SERVICE BULLETIN

APPLICATION OF COLLECTIVE CONTROL INDEX MARK

9B67-004

Figure 1. Application of Index Mark to Collective Control Module

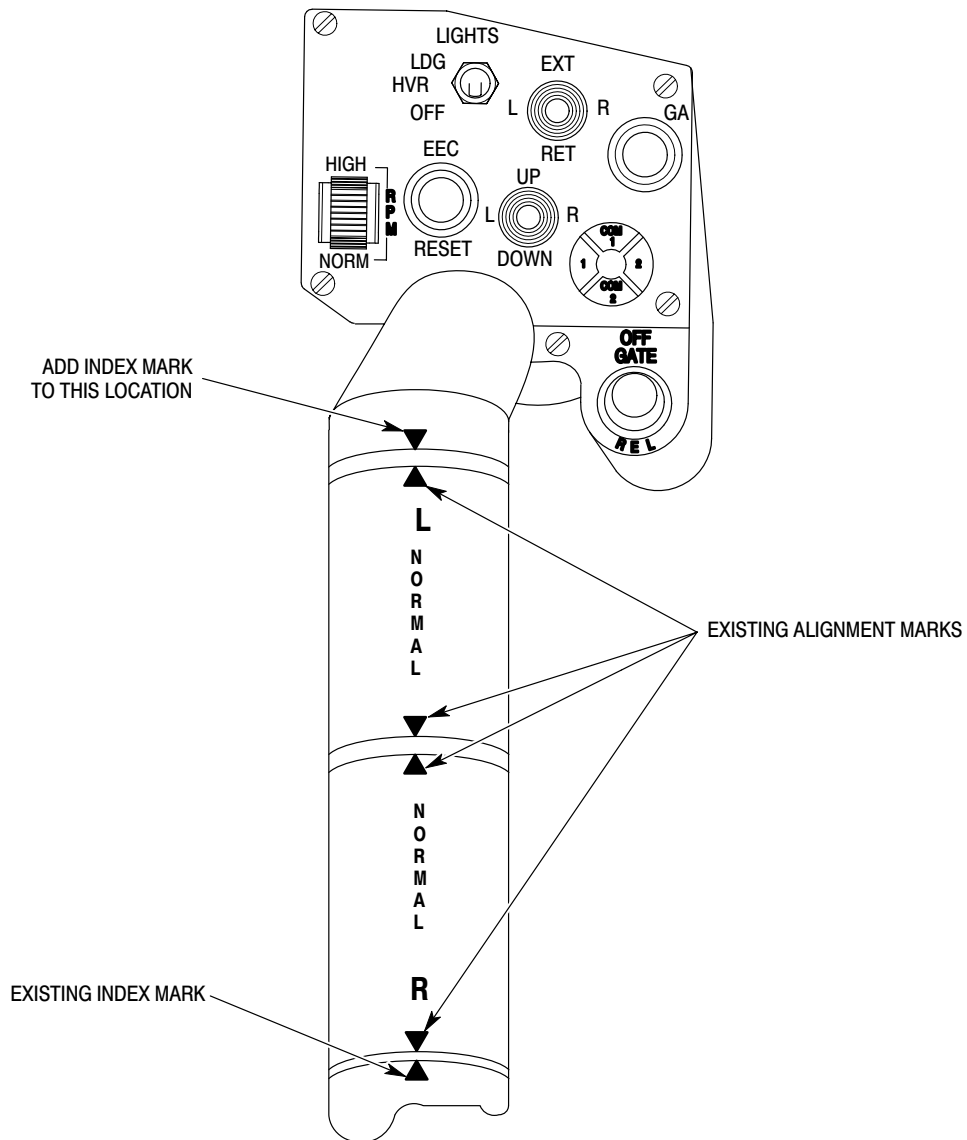
Required modification of the Collective Control Module (P/N 900C3010050-107). This modification consists of applying an additional index mark to the control module, in clear view of the pilot, to assist the pilot in locating the throttle normal operation detent position and twist grip alignment.

- (1). Paint a triangle shaped index mark in location shown on Figure 1 with white paint per FED-STD-595, No. 17875.
- (2). After the white paint has dried, apply a clear protective coating over the index mark.
